**Public Participation Summary**

Radioactive Material License UT1900479 Renewal  
Ground Water Quality Discharge Permit UGW370004 Renewal

Sequoyah Fuels Alternate Feed Request  
Energy Fuels Resources (USA) Inc. (Energy Fuels)  
White Mesa Uranium Mill  
San Juan County, Utah

*Figure 5: Cell 2 Radon Flux Measurement Locations*

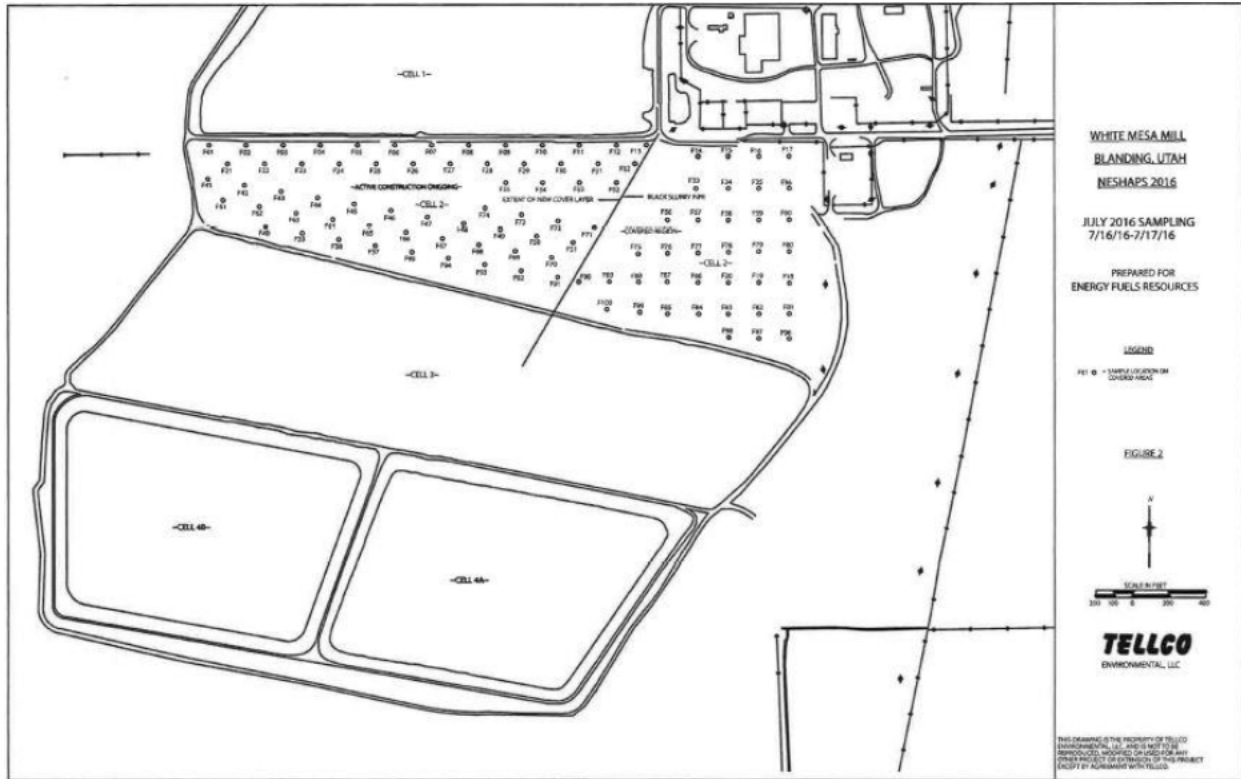
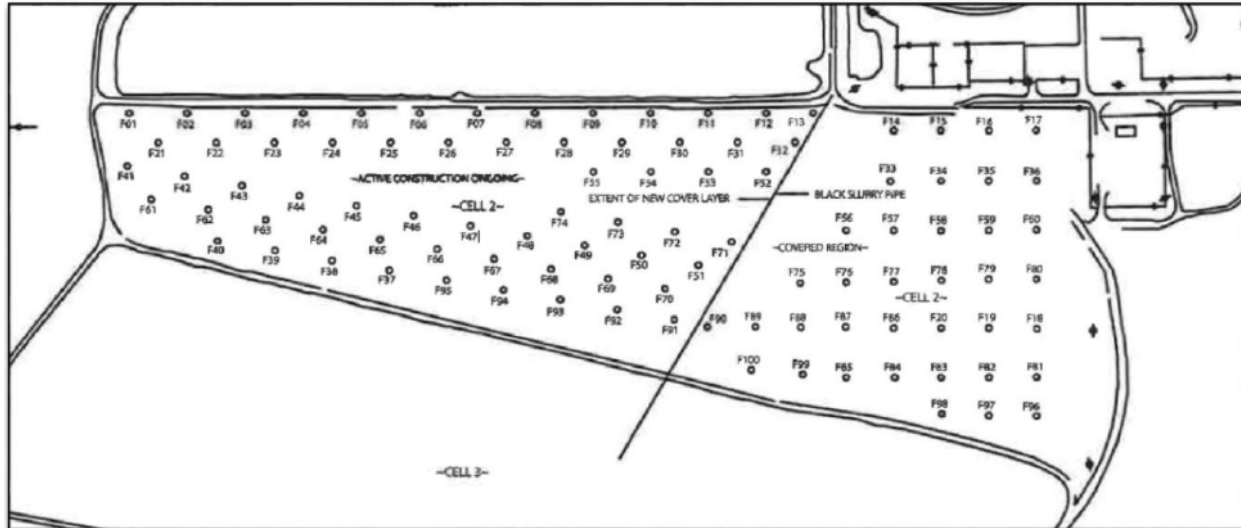
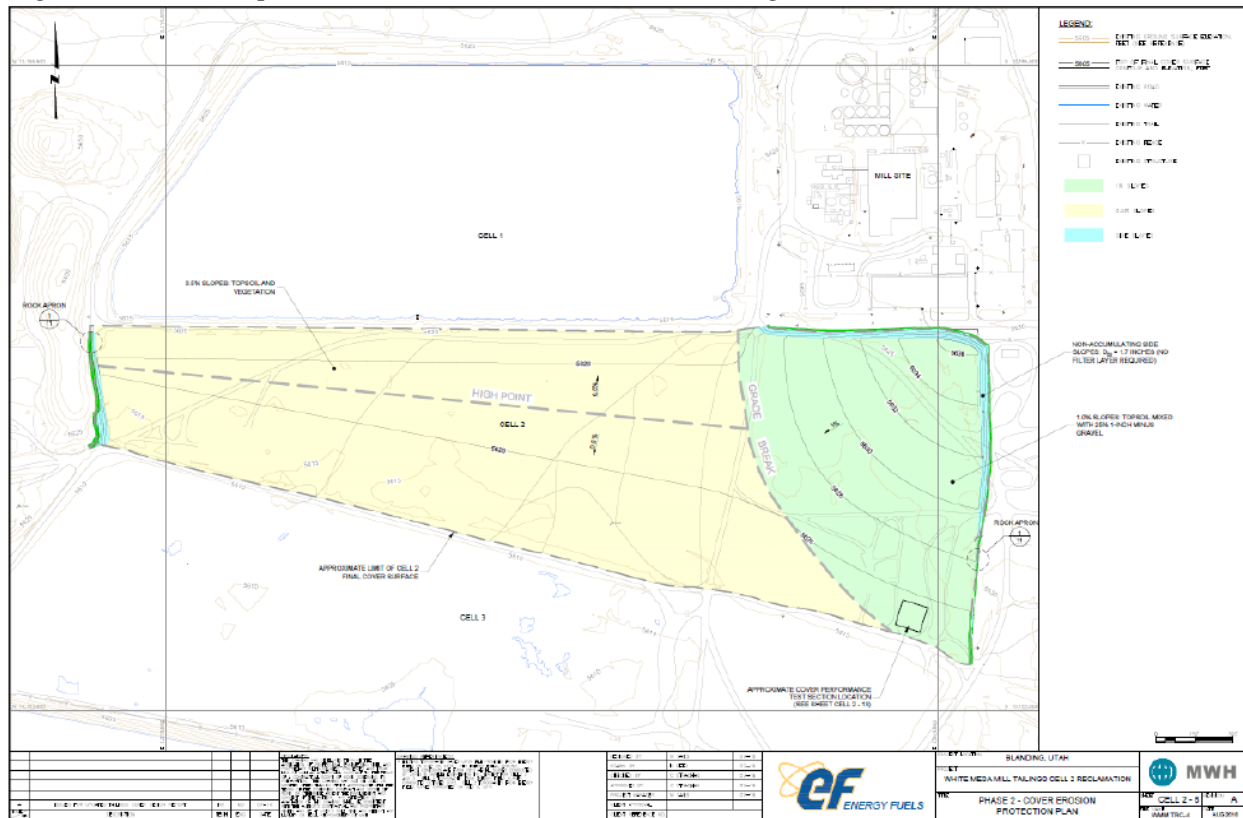
#### ***I-II-D Require EFRI to permanently close Tailings Cell 2.***

*The following diagram, Figure 5, is an attachment at the end of the CELL 2 RADON FLUX Report for July 2016. In the first third (from the left) of Cell 2 are the words “active construction ongoing”, with no radon flux measurements taken at that location. (Also this designation was not on the 2015 flux reports for NESHAPs compliance). The diagram was enlarged in Figure 6 so that the words on the original document are visible. Figure 7 below is the from Appendix L, Cell 2 Reclamation Cover Implementation and Performance Assessment Plan, to the WMM Updated Tailings Cover Design Report, In Figure 7, the area in the southeast section of Cell 2 is the test plot for the cover design described in Reclamation Plan 5.1. This plan further describes how Cell 2 has been covered with 3 feet of soil, however as shown in Figure 5, another activity is ongoing. This is an intrusion to the protective radon barrier, which is supposed to ensure less than 20 pCi/m<sup>2</sup>-sec. At the minimum, this area must be measured for radon flux and the results presented in the quarterly report which is required per DWMRC.*
